**Evaluation of Regulations for  
the Expansion of the Flower  
Garden Banks National Marine  
Sanctuary Expansion**

**White Paper**

**October 2016**

**Figure 7.** East Flower Garden Bank, West Flower Garden Bank and Horseshoe Bank. Existing FGBNMS boundary (in red), existing HAPC (hatched lines) and proposed expansion (outlined in purple).

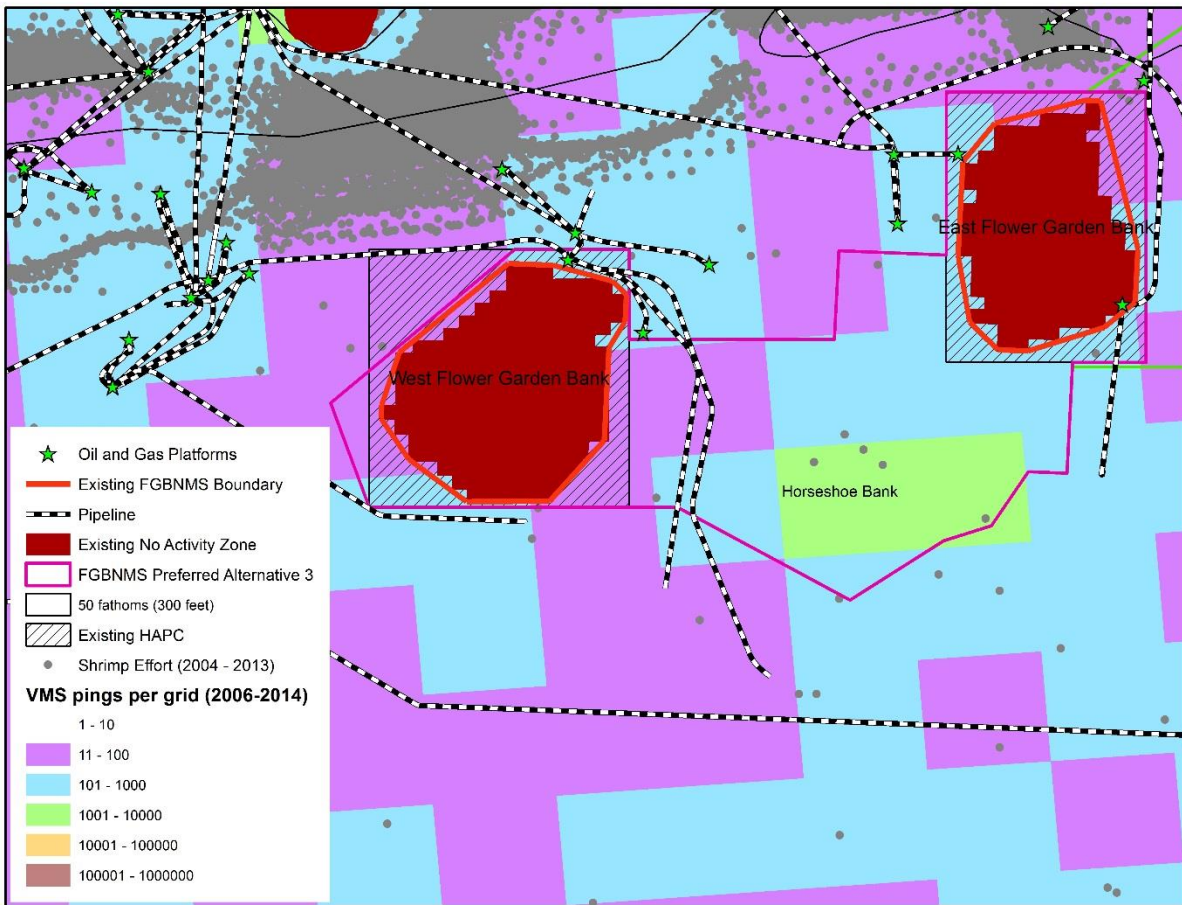
There are sections of the East and West Flower Garden Banks that are already no bottom tending gear HAPCs. However, with the FGBNMS's Preferred Alternative 3, the expansion to include Horseshoe Bank would greatly affect the reef fish fishery in the southeast portion of the proposed boundary (Figure 7). Many of these fisheries operate using anchors in soft sediment, and historic fishing practices should be accommodated as historical oil and gas use is accommodated. All recommendations are based on Figure 7.

- Maintain fishing regulations in the existing HAPCs
- Continue to allow historic fishing practices in the area highlighted in green in the southeast section by the following:
  - Allow anchoring by fishing vessels over soft sediment (anchors used should be specific to anchoring in soft sediment (e.g. Danforth anchors, etc)
  - Allow historic fishing practices in the area to continue as long as it is not over the hard bottom reef
  - Establish a truncated “no bottom tending gear zone” for Horseshoe bank, similar to the no activity zones established over East and West Flower Garden Banks, that would delineate this “no bottom tending gear zone.”
  - In the “no bottom tending gear zone,” prohibit all fishing that is not by hook-and-line and prohibit all anchoring

**Figure 9.** Gulf of Mexico Fishery Management Council suggested revision to the boundary of the proposed expansion in Preferred Alternative 3.

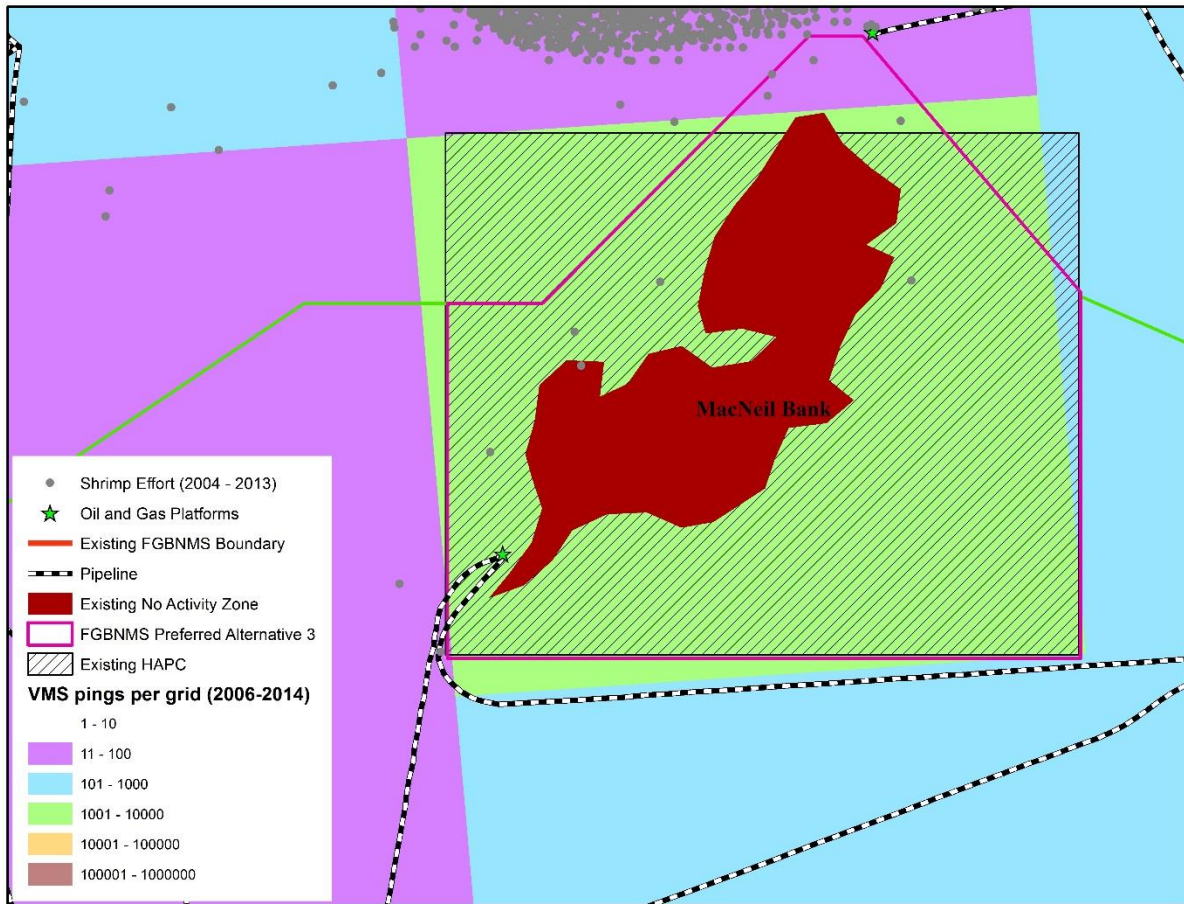
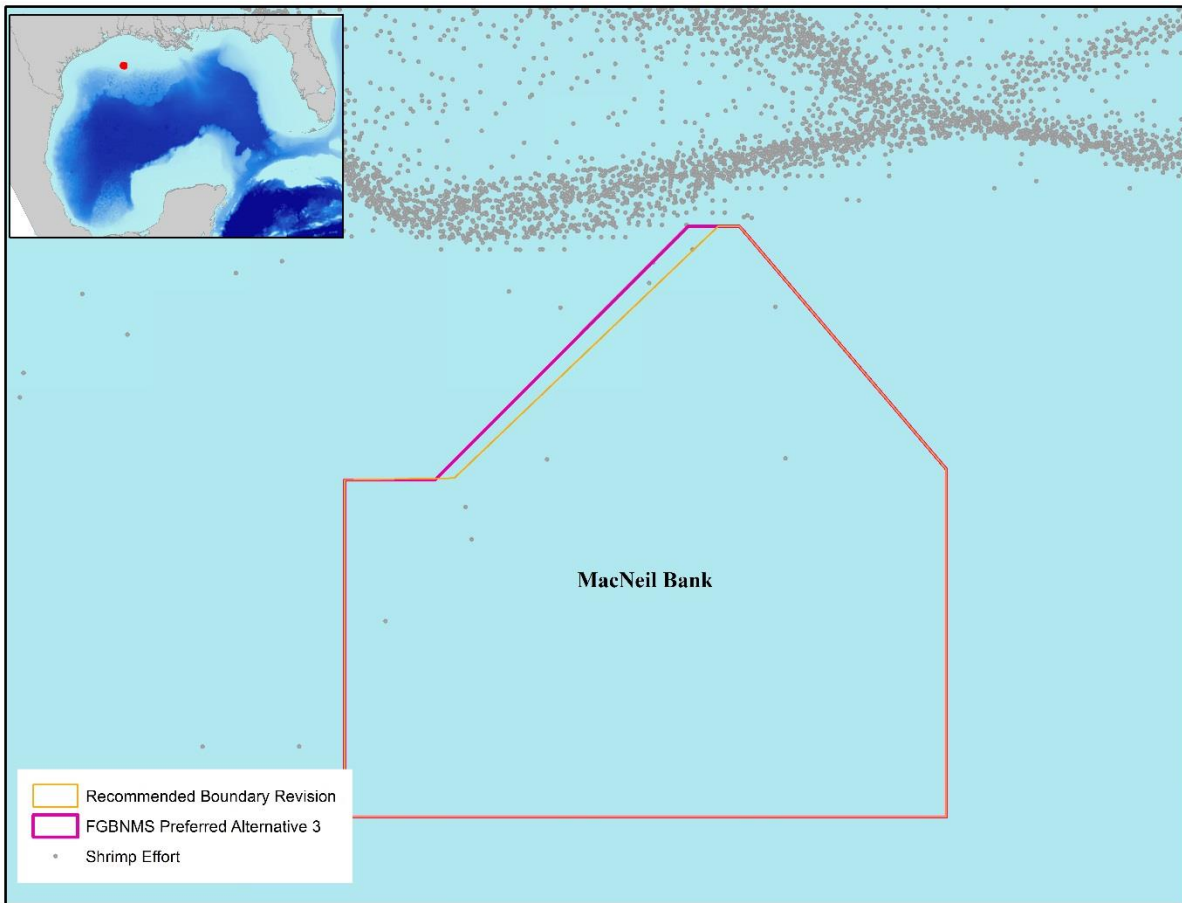
MacNeil Bank is already designated as a HAPC with no fishing regulations (Figure 8). The Council has already provided information to the FGBNMS to revise the proposed northwestern boundary (Preferred Alternative 3) slightly to accommodate the shrimp fishery historic use (Figure 9). All recommendations are based on Figure 9.

- Continue to allow historic fishing practices in the area highlighted in green in the southeast section by the following:
  - Establish a truncated “no bottom tending gear zone (including anchors)” for MacNeil bank that coincides with the established BOEM “no activity zone” established
  - Prohibit trawling within the boundaries of the proposed expansion of FGBNMS
  - Allow anchoring by fishing vessels over soft sediment (anchors used should be specific to anchoring in soft sediment (e.g. Danforth anchors, etc) as long as this area is not in the “no bottom tending gear zone.”
  - Allow historic fishing practices in the area to continue as long as they comply with the bottom tending gear regulations and have a FGBNMS endorsement (as described above)

**Figure 10.** Rankin, Bright, and 28 Fathom Banks: existing HAPC (hatched lines) and proposed expansion (outlined in purple).

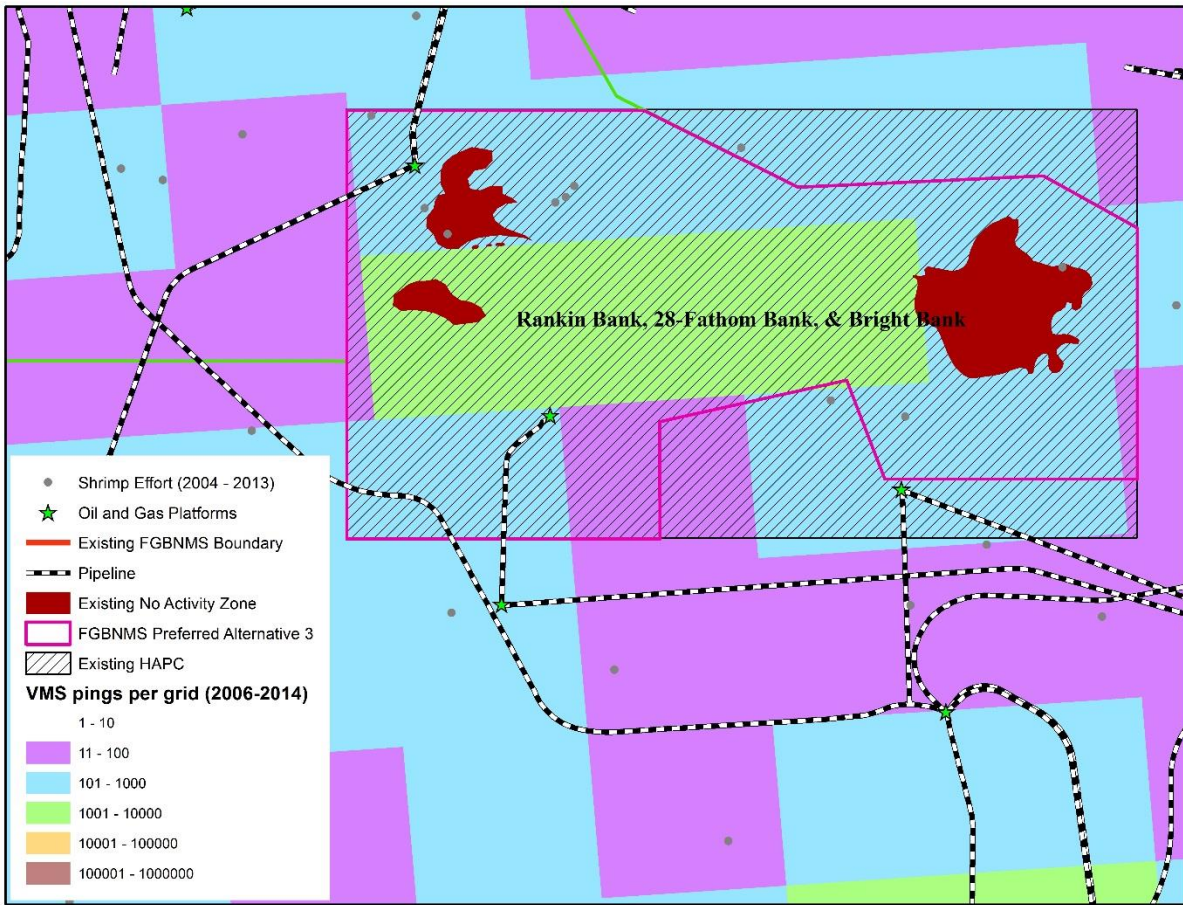
Rankin Bank and Bright Bank are already designated as a HAPC but have no fishing regulations (Figure 10). The green box in Figure 11 is an area of high usage by the reef fish fishery and this historic fishing practices should be incorporated into the regulations considered for the FGBNMS expansion. All recommendations are based on Figure 10.

- Continue to allow historic fishing practices in the area highlighted in green in the southeast section by the following:
  - Establish a truncated “no bottom tending gear zone (including anchors)” for Rankin, Bright and 28 Fathom Banks that coincide with the established BOEM “no activity zone” established
  - Prohibit trawling within the boundaries of the proposed expansion of FGBNMS
  - Allow anchoring by fishing vessels over soft sediment (anchors used should be specific to anchoring in soft sediment (e.g. Danforth anchors, etc) as long as this area is not in the “no bottom tending gear zone”
  - Allow historic fishing practices in the area to continue as long as they comply with the bottom tending gear regulations and have a FGBNMS endorsement (as describe above)

**Figure 11.** Geyer Bank: existing HAPC (hatched lines) and proposed expansion (outlined in purple).

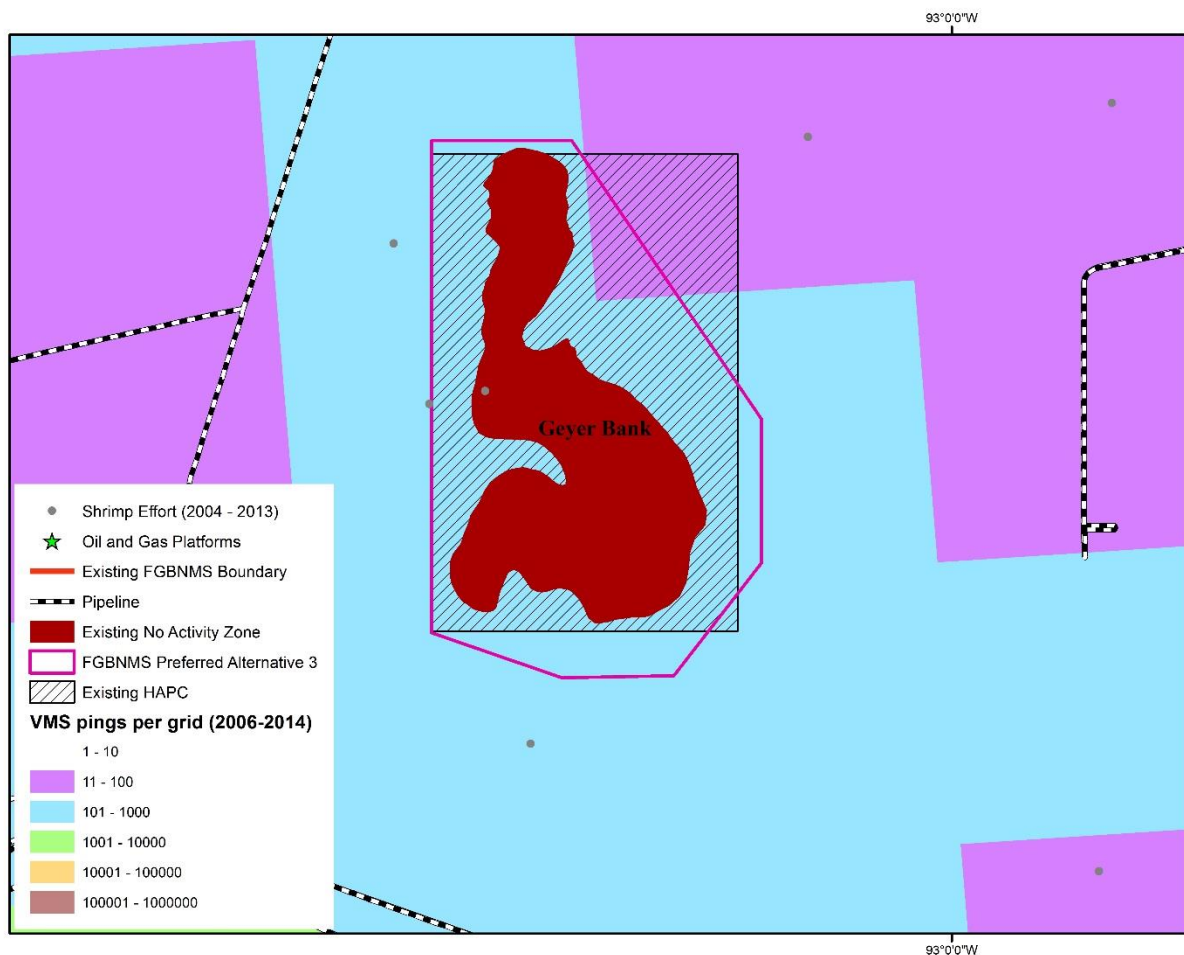
Geyer Bank is already designated as a HAPC but has no fishing regulations (Figure 11). All recommendations are based on Figure 11.

- Establish a truncated “no bottom tending gear zone (including anchors)” for Geyer Bank that coincides with the established BOEM “no activity zone” established
- Prohibit trawling within the boundaries of the proposed expansion of FGBNMS
- Allow anchoring by fishing vessels over soft sediment (anchors used should be specific to anchoring in soft sediment (e.g. Danforth anchors, etc) as long as this area is not in the “no bottom tending gear zone”
- Allow historic fishing practices in the area to continue as long as they comply with the bottom tending gear regulations and have a FGBNMS endorsement (as described above)

**Figure 13.** Sonnier Bank: existing HAPC (hatched lines) and proposed expansion (outlined in purple).

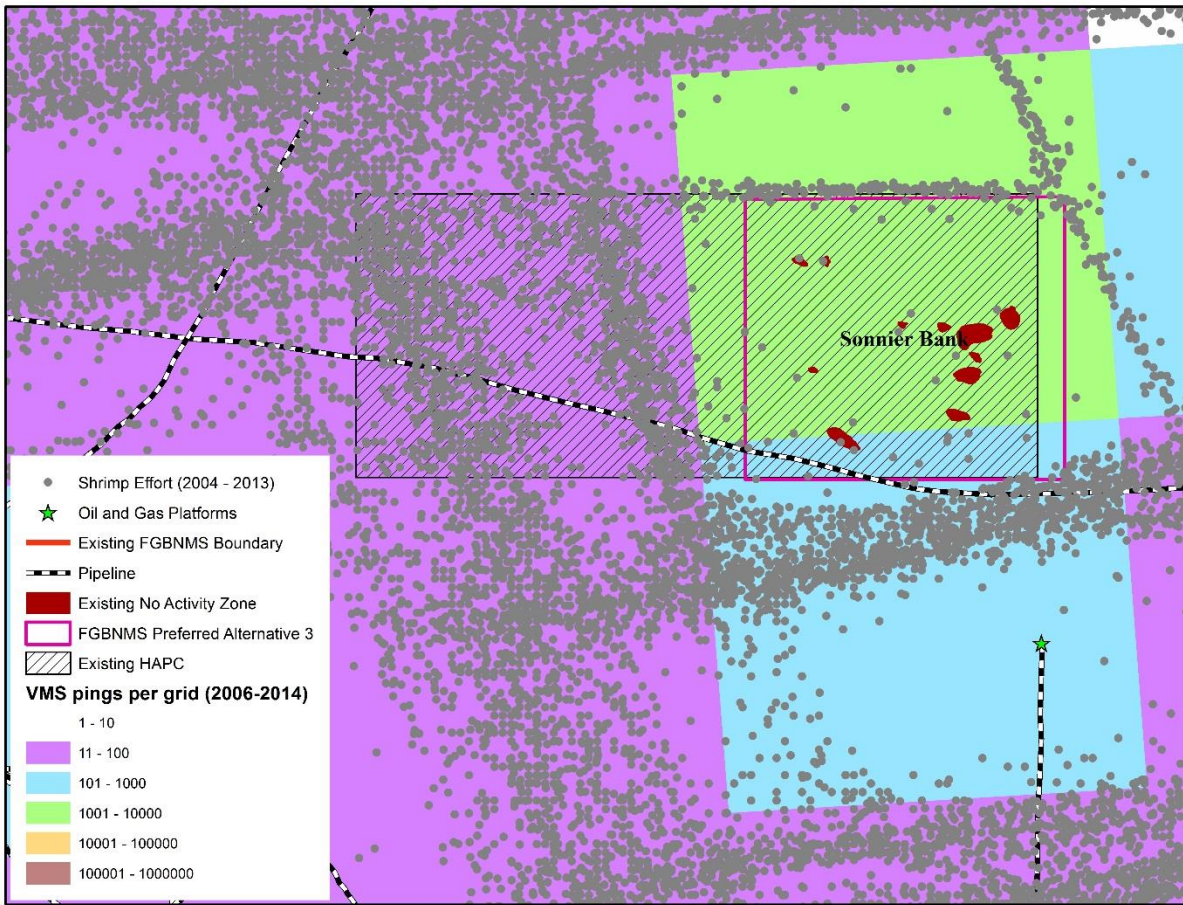
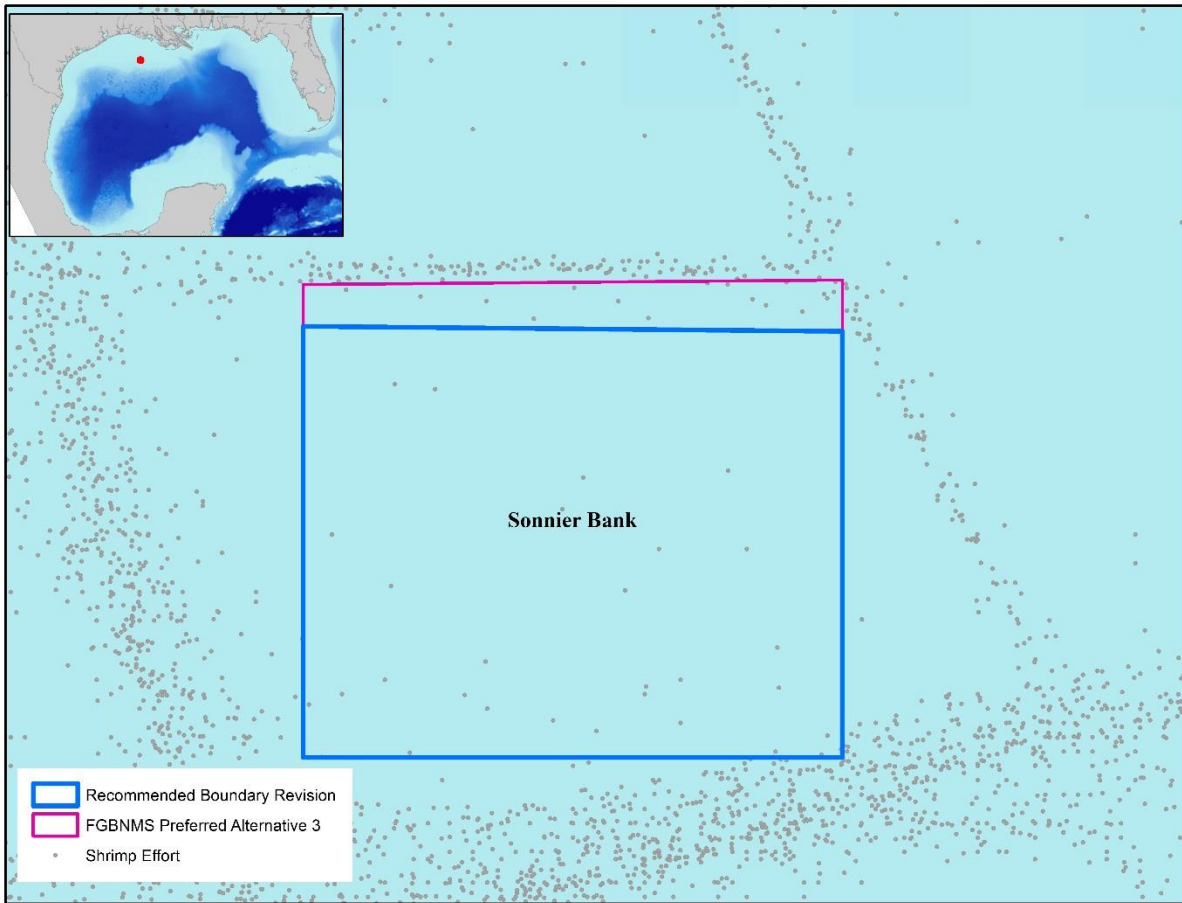
Sonnier Bank is designated as a HAPC but has no fishing regulations (Figure 13). The green box in Figure 15 is an area of high usage by the reef fish fishery and this historic fishing practices should be incorporated into the regulations considered for the FGBNMS expansion.

Additionally, the shrimp fishery heavily uses the northern portion of the proposed boundary; the Council has already made recommendations to the FGBNMS about revising the boundary to allow for historical usage (Figure 14). All recommendations are based on Figure 13.

- Continue to allow historic fishing practices in the area highlighted in green in the southeast section by the following:
  - Establish a truncated “no bottom tending gear zone (including anchors)” for Sonnier Bank that coincides with the established BOEM “no activity zone” established
  - Prohibit trawling within the boundaries of the proposed expansion of FGBNMS
  - Allow anchoring by fishing vessels over soft sediment (anchors used should be specific to anchoring in soft sediment (e.g. Danforth anchors, etc) as long as this area is not in the “no bottom tending gear zone.”
  - Allow historic fishing practices in the area to continue as long as they comply with the bottom tending gear regulations and have a FGBNMS endorsement

**Figure 15.** Alderdice Bank: existing HAPC (hatched lines) and proposed expansion (outlined in purple).

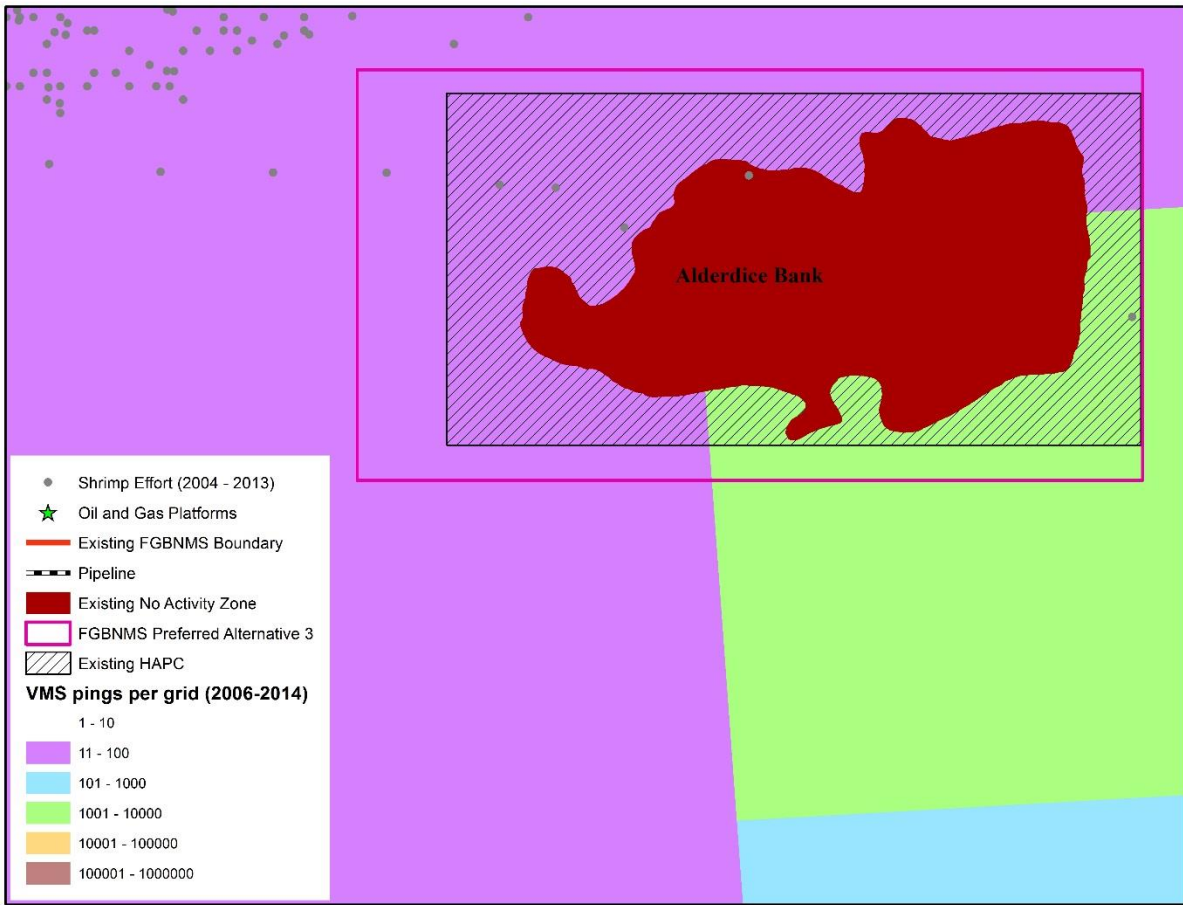
Alderdice Bank is designated as a HAPC but has no fishing regulations (Figure 15). The green box in Figure 15 is an area of high usage by the reef fish fishery and this historic fishing practices should be incorporated into the regulations considered for the FGBNMS expansion. All recommendations are based on Figure 15.

- Continue to allow historic fishing practices in the area highlighted in green in the southeast section by the following:
  - Establish a truncated “no bottom tending gear zone (including anchors)” for Alderdice Bank that coincides with the established BOEM “no activity zone” established
  - Prohibit trawling within the boundaries of the proposed expansion of FGBNMS
  - Allow anchoring by fishing vessels over soft sediment (anchors used should be specific to anchoring in soft sediment (e.g. Danforth anchors, etc) as long as this area is not in the “no bottom tending gear zone”
  - Allow historic fishing practices in the area to continue as long as they comply with the bottom tending gear regulations and have a FGBNMS endorsement
